TO: Honorable Chairman Hertz and Members of the Mount Kisco Planning Board

SUBJECT: NY Luxury Motors of Mount Kisco, INC.  
299 Kisco Avenue, Property ID #69.49-2-1

FROM: Jan K. Johannessen, AICP   
Village Planner

RE: Site Plan (Formal) & Wetland Permit  
NY Luxury Motors  
299 Kisco Avenue  
Section 69.49, Block 2, Lot 1

Sheet Number:  
**A201a**

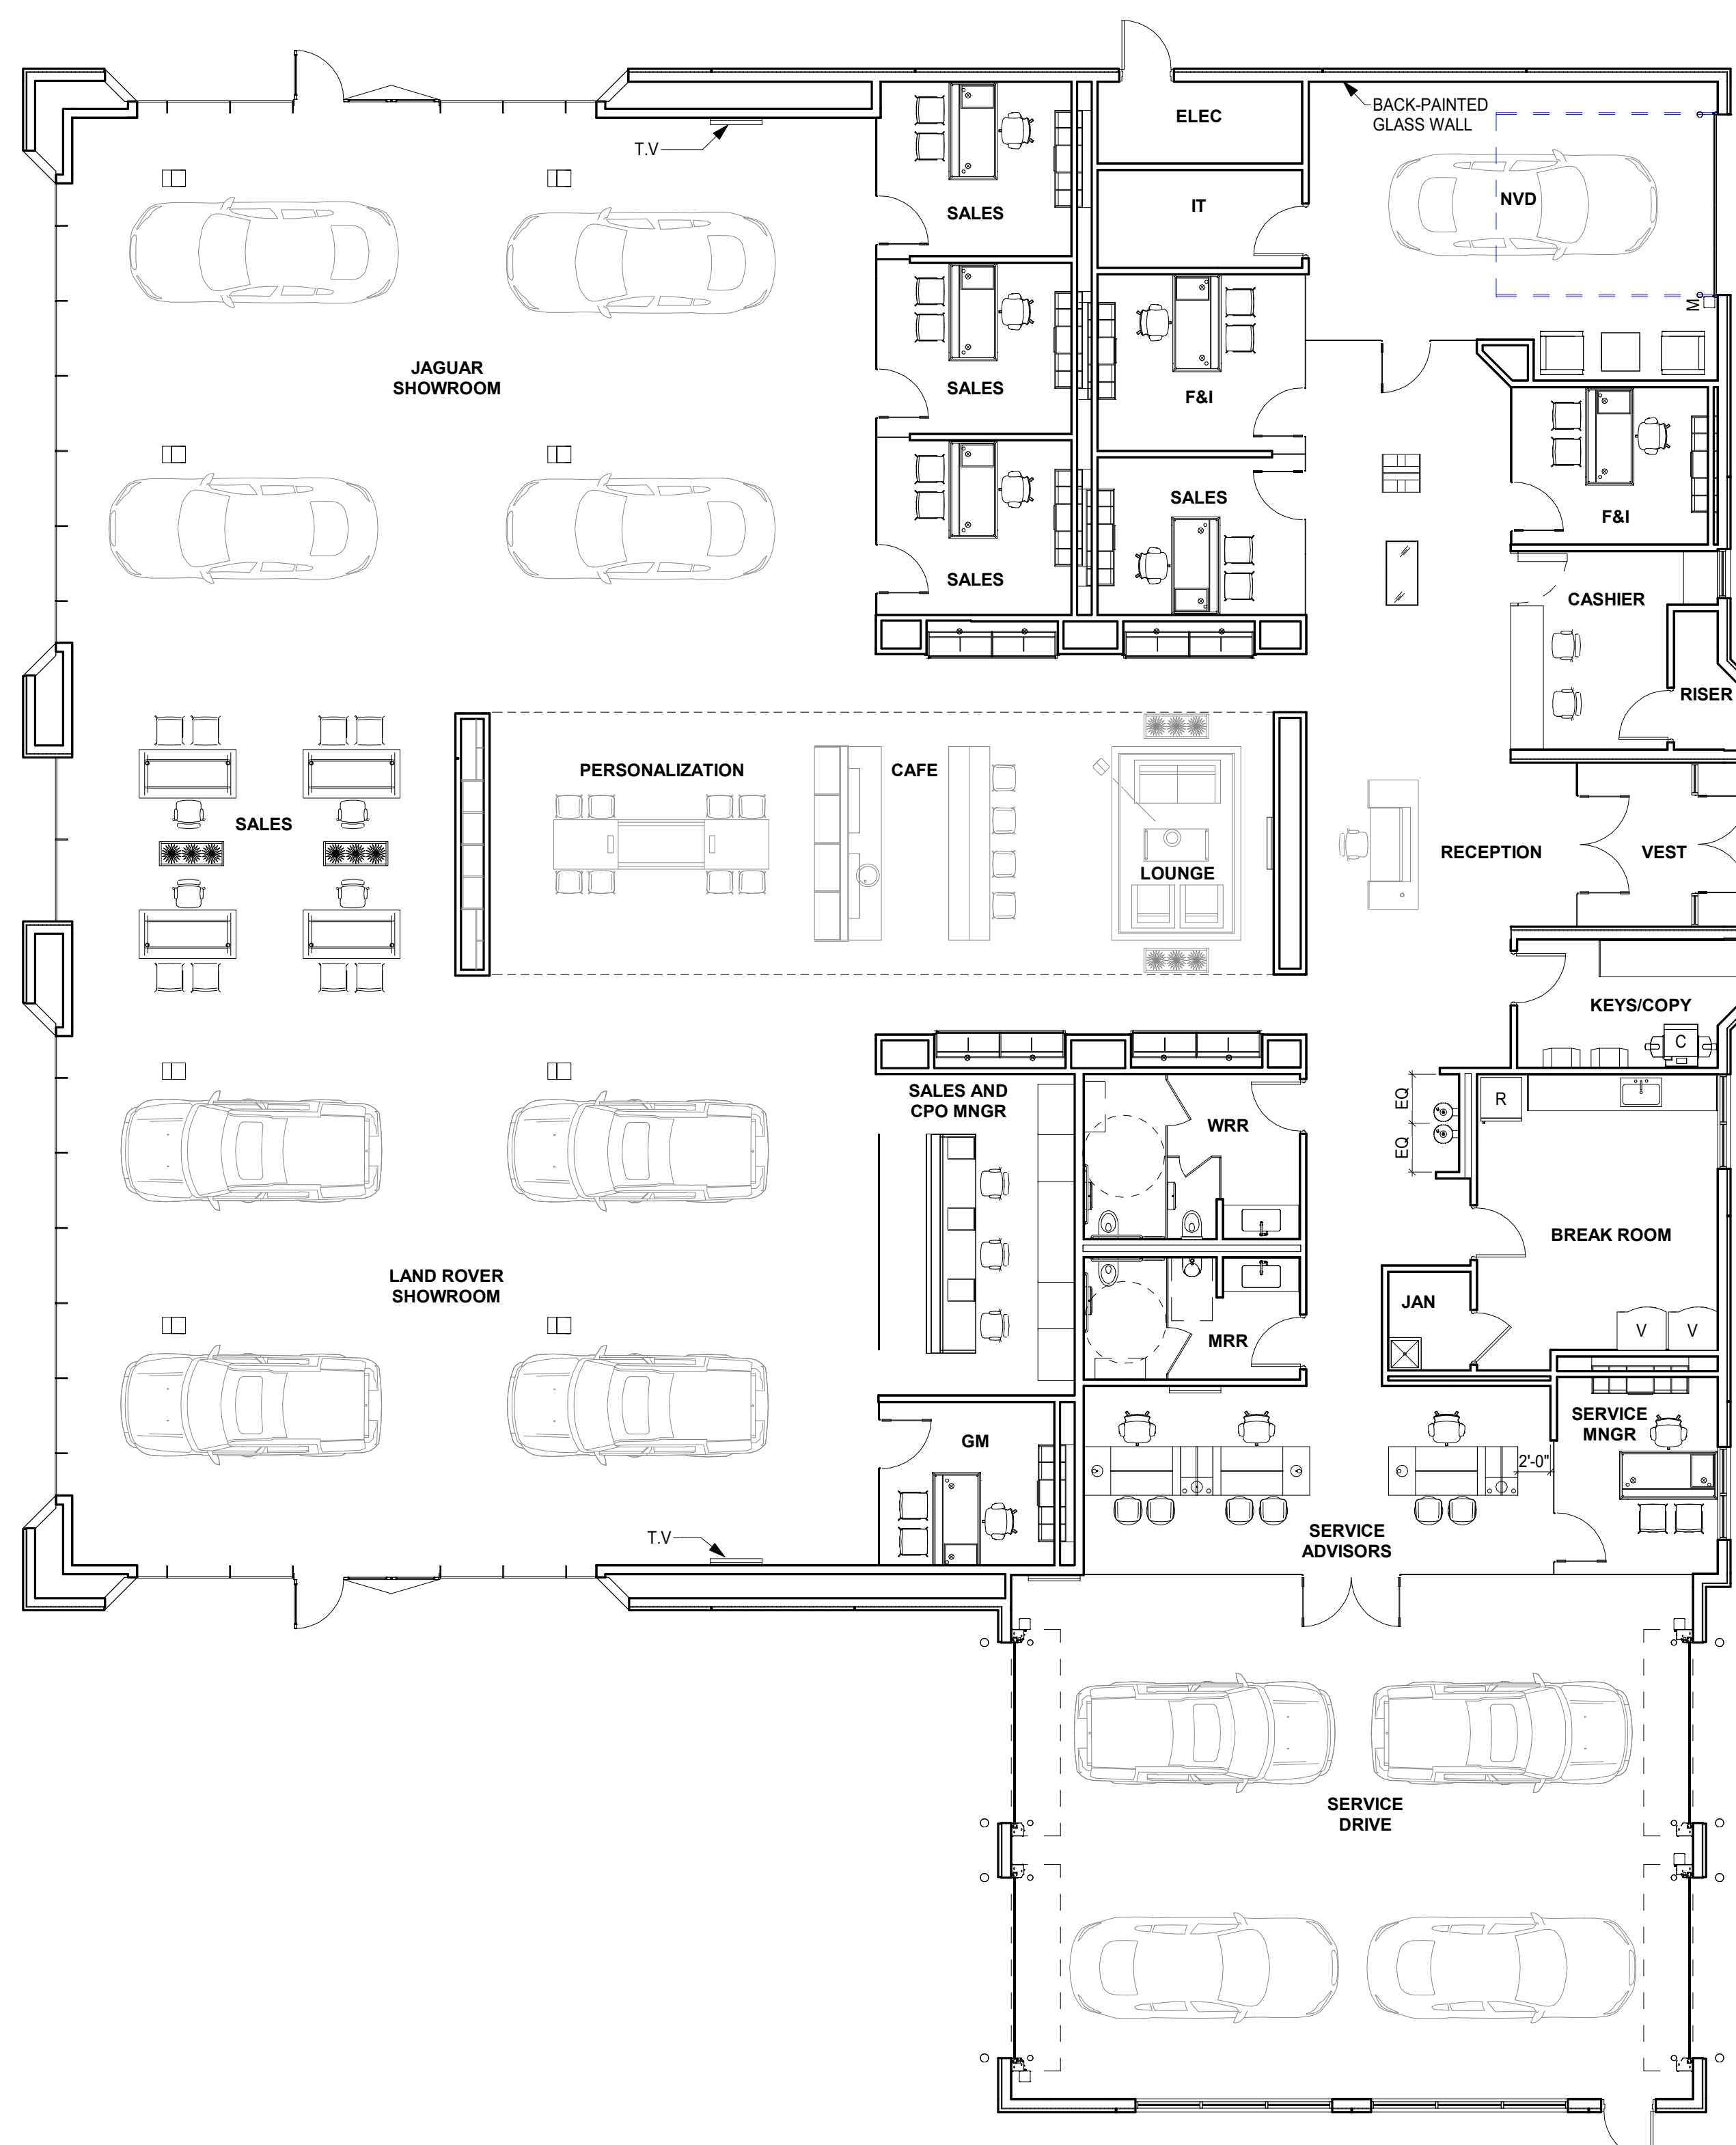
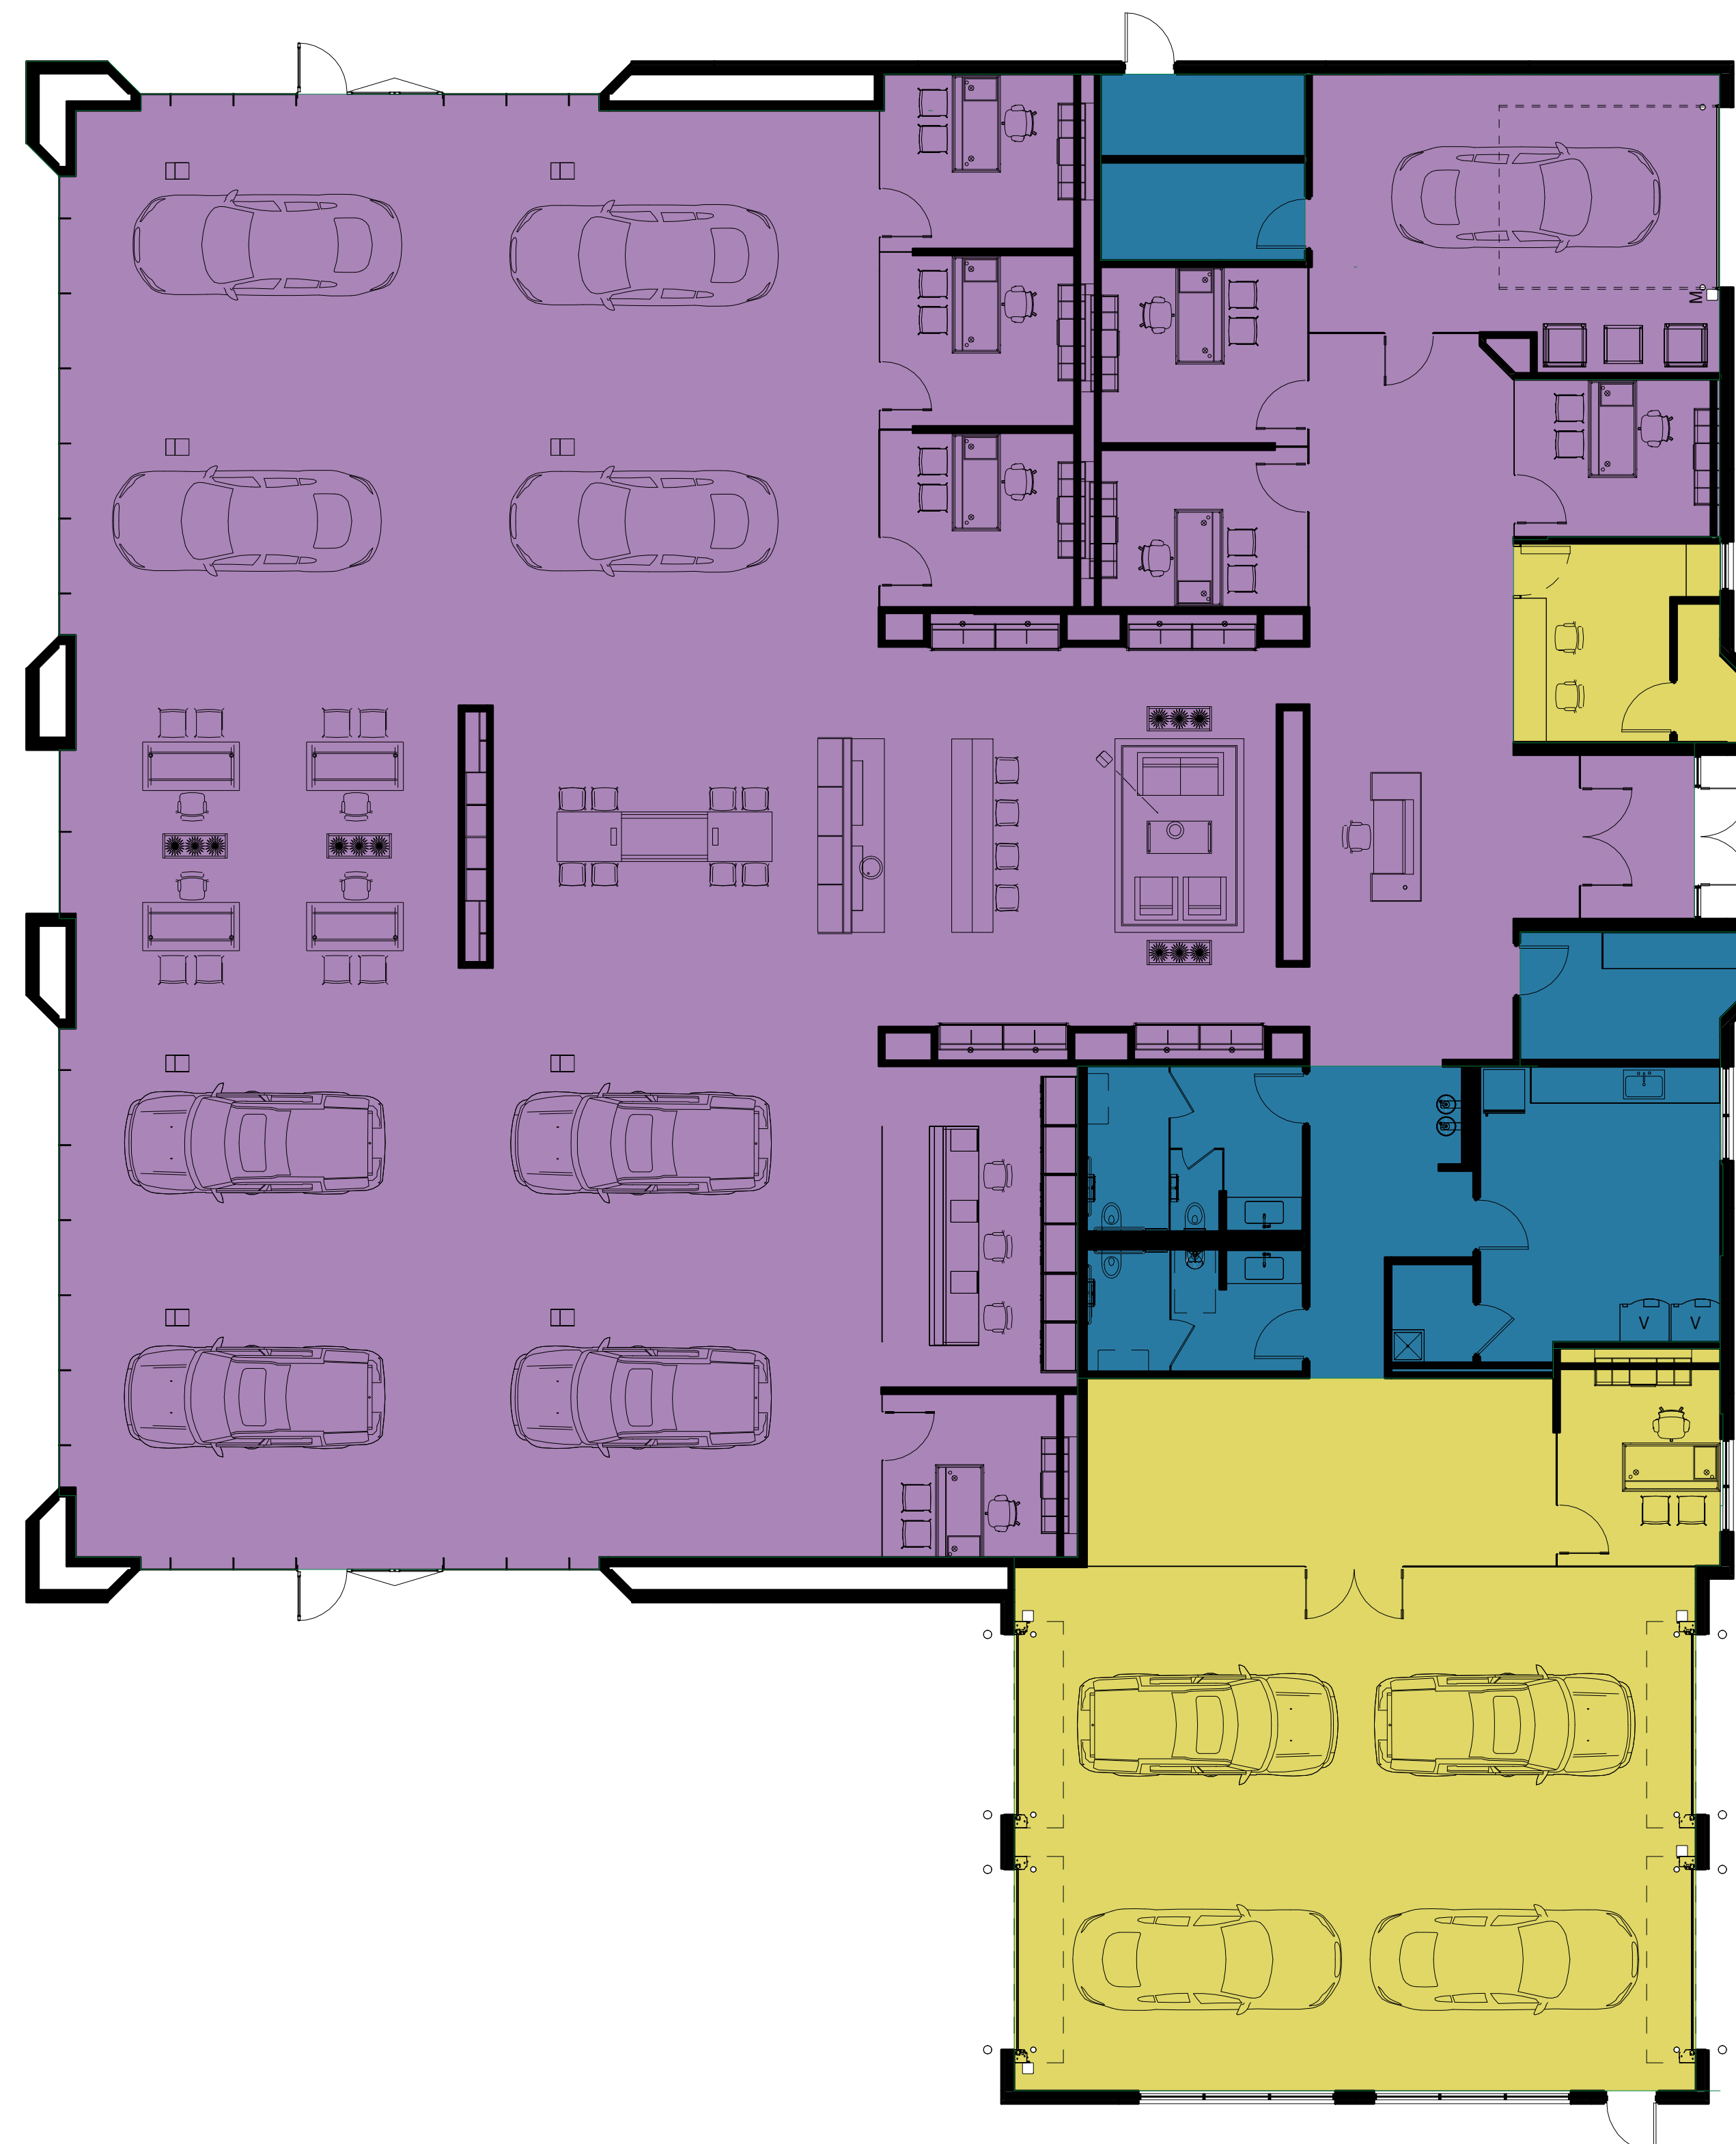
Proposed is a new building design for the 9,463 square ft. Jaguar/Land Rover dealership which includes showrooms, sales offices, service advisor areas, and other incidental areas to support the dealership. No maintenance or service/repairs will be performed at the proposed location. A separate four-car drop off area (adjacent to the service writers) is proposed which will be utilized to accept vehicles for service however, they will be driven to another location for service that is not located in Mount Kisco.
